CITY OF WASHINGTON, MISSOURI  
Department of Planning and Engineering Services  
405 JEFFERSON STREET • WASHINGTON, MO 63090  
636.390.1010 phone • 636.239-4649 fax

To: Planning and Zoning Commission

Re: File # 16-0401 and 16-0402 – Hilltop Homes Rezoning and Plat 6

Synopsis: The applicant is requesting approval of a rezoning at 1107 and 1111 Bieker Road from R-2 Two Family Residential to R-1C Single Family Attached and a preliminary plat for Hilltop Homes Plat 6.

# HILLTOP HOMES PLAT 6

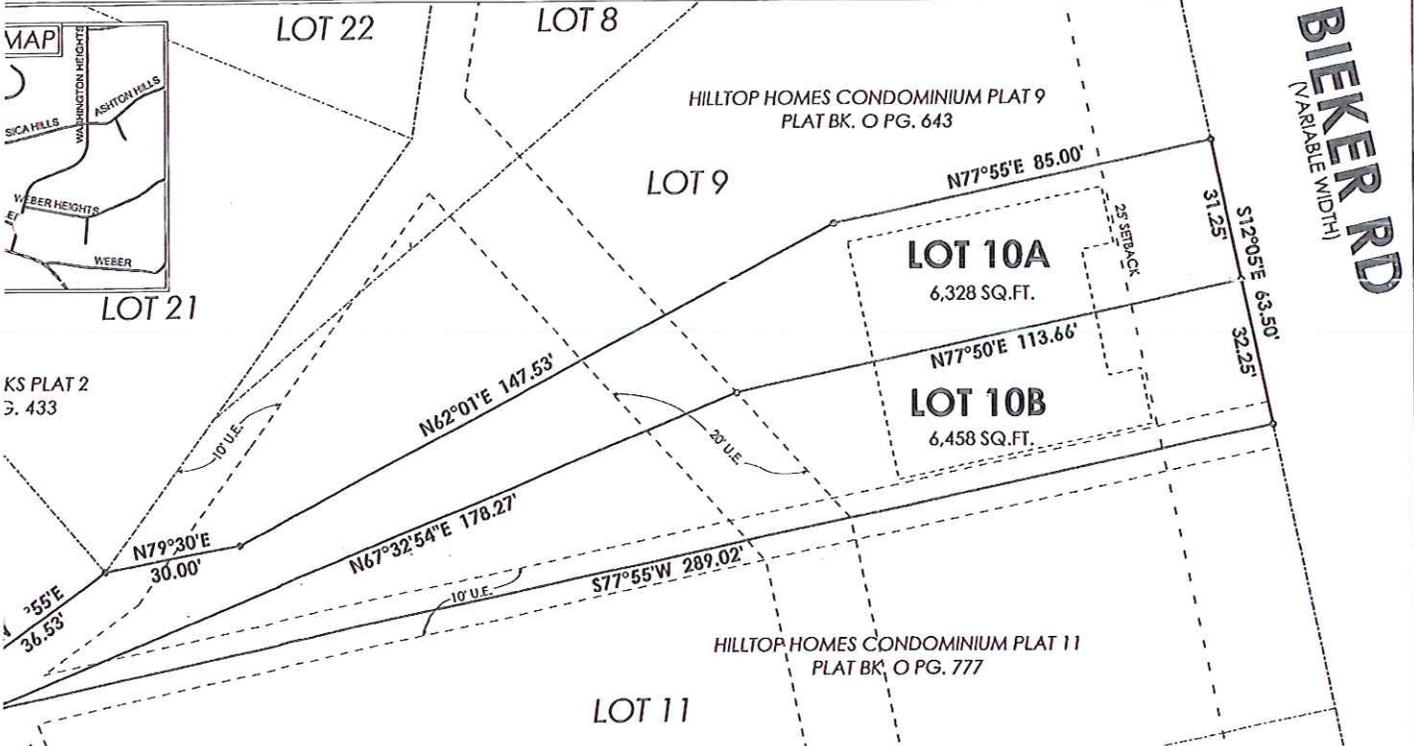
In junction with the proposed rezoning, the applicant is requesting a preliminary plat to separate the lot into 2 separate parcels. This would allow the owner to sell the lot without creating a condominium plat. The proposed plat shows two lots that are larger than 6,000 square feet in size, meeting the minimum lot size for the R-1C zone district. All appropriate easements are shown and the plat meets minimum City requirements.

Staff recommends approval of both the rezoning from R-2 to R-1C and the Preliminary Plat of Hilltop Plat 6
